## MODEL 42

## FLYWHEEL

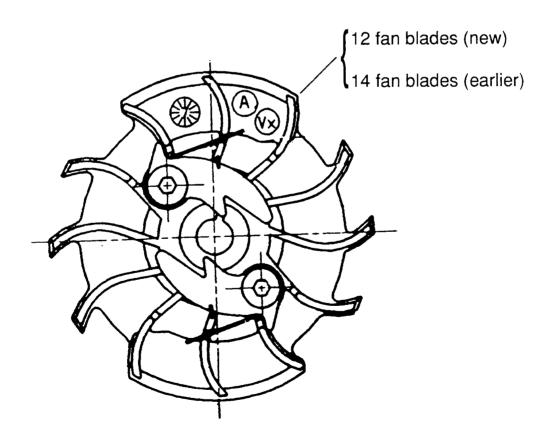
In order to improve the starting function and to reduce the vibrations a new lighter flywheel is introduced in our production. It is previously introduced on the model 242.

New ref. no. 503 50 53-02

Description Flywheel compl. SE Excluded ref. no. 501 63 26-01

The change is introduced in our production from serial number: 1230398
